UNITED STATES ENVIRONMENTAL PROTECTION AGENCY  
REGION 4  
ATLANTA FEDERAL CENTER  
61 FORSYTH STREET  
ATLANTA, GEORGIA 30303-8960

FERNANDINA OCEAN DREDGED MATERIAL DISPOSAL SITE

## SITE MANAGEMENT AND MONITORING PLAN

ADDENDUM #1

# PROPOSED DISPOSAL ZONE

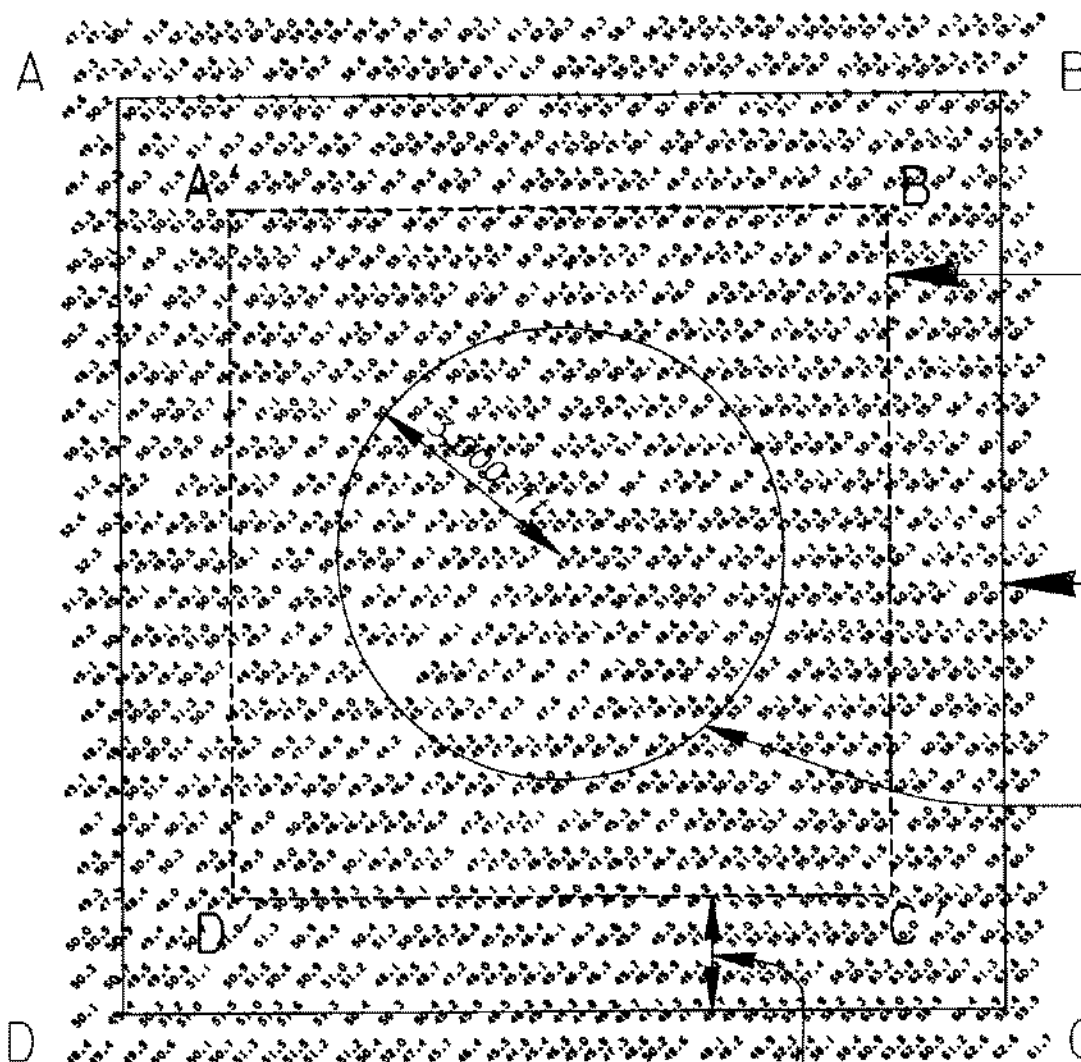
The U.S. Army Corps of Engineers requests EPA's concurrence to modify the referenced document. We wish to change the paragraph entitled, "Disposal Location." The paragraph currently specifies that disposal should occur within a radius of 3,000 feet of the center of the ODMDS. This region accounts for only 20% of the total ODMDS. We propose to enlarge the recommended disposal zone to approximately 56% of the ODMDS. Pending concurrence from EPA and other interested parties, the modified SMMP would state that during use of the ODMDS, dredged material will be placed at least 1,500 feet from ODMDS limits (see attached diagram).

The nature of the request is to prevent a potential navigation hazard caused by mounding of dredged material within the ODMDS. A larger disposal zone will allow a greater distribution of material, while still containing the dispersed material within the ODMDS. You may contact Mr. Brian Brodehl of my staff at 904-232-3600 for additional information.

Disposal Location. Disposal shall occur no less than 1,500 feet inside the site boundaries. This buffer is defined by the following coordinates (multiple datums and coordinate systems are provided for completeness):

Modeling efforts have shown that this buffer will contain the initial disposal mound within the site boundaries for projects up to 950,000 cubic yards (EPA, 1998). Projects greater than 950,000 are not expected, however, if proposed, modeling will be required to determine an appropriate buffer to contain the initial disposal mound within the ODMDS boundaries.
